# Historic Preservation Design Review

## HP-12-09, 38 N. Main St. – Replacement Doors (City)

*Picture #2:* The rear door indicated by the red arrow is to be replaced by a door similar to the one pictured right.

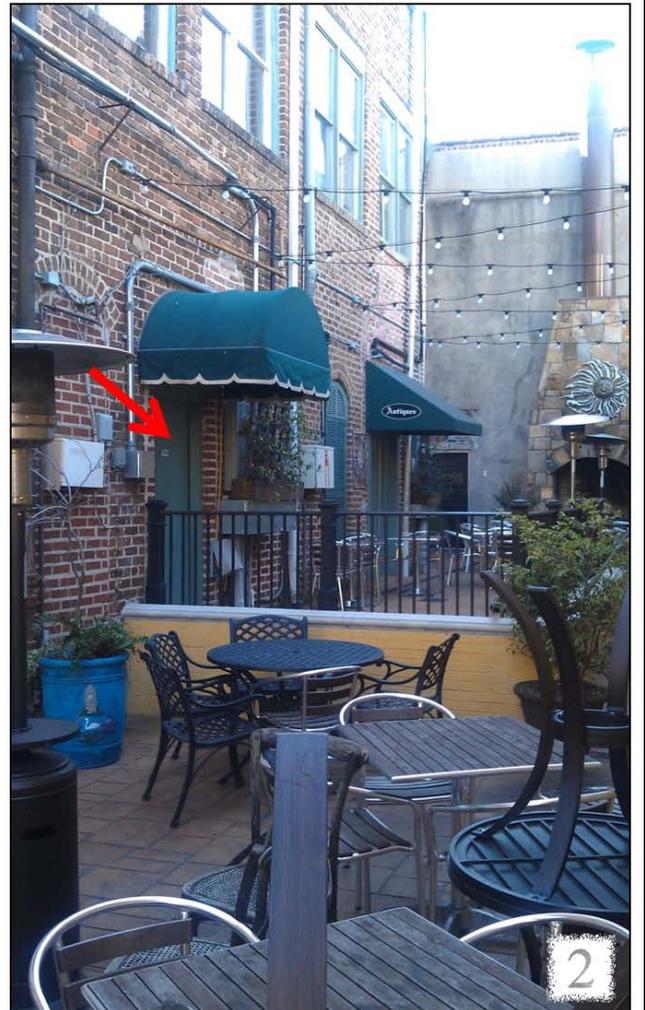
*Picture #1:* The N. Main St. entrance to 38 N. Main St. The entrance door indicated by the red arrow is to be replaced with a door similar to the one pictured to the right.

Also, the canopy shown in picture #1 is to be removed.

The entrance doors on both the front and back of the structure are not original to the building. The proposed new door as shown on the graphic on page 2 of this report is consistent with the recommended style of replacement door as outline in Guideline #7.f.

Ordinarily removal of an existing awning is not appropriate, however; this projecting awning is not original to the building and likely the result of façade work done in the 1980s. Removal of the arched projecting awning is not contrary to the established guidelines. The current shape appears to have been selected to mimic detailing on the upper façade but does not relate to the shape of the opening that it covers.

Staff has reviewed this request in accordance with the design guidelines. Staff recommends approval of this request.
